Dogger Bank South Offshore Wind Farm

**Appendix E8 to the Natural England Deadline 8 Submission**  
**Natural England's comments and updated advice on Fish and Shellfish**

Planning Inspectorate Reference EN010125

4<sup>th</sup> July 2025

**Figure 1:** Section of Figure 17.8 taken from the Applicant's Herring Spawning Plan [REP7-135]. The black rectangle has been added by Natural England to highlight where the restriction boundary (red line) does not align with the underlying substrate boundary (black line).

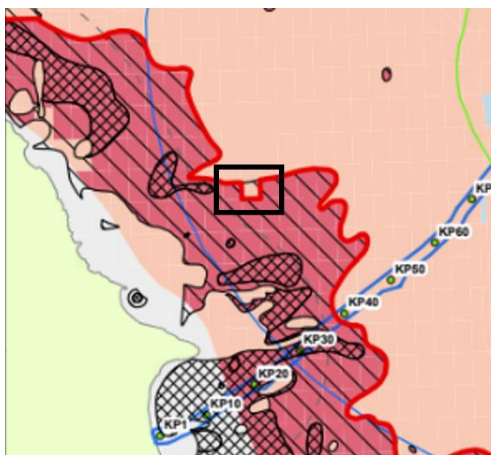
To note – we believe there may be an error in the restriction boundary line presented in the Herring Spawning Plan [REP7-135] where it does not align with the underlying marginal substrates boundary (Figure 1).
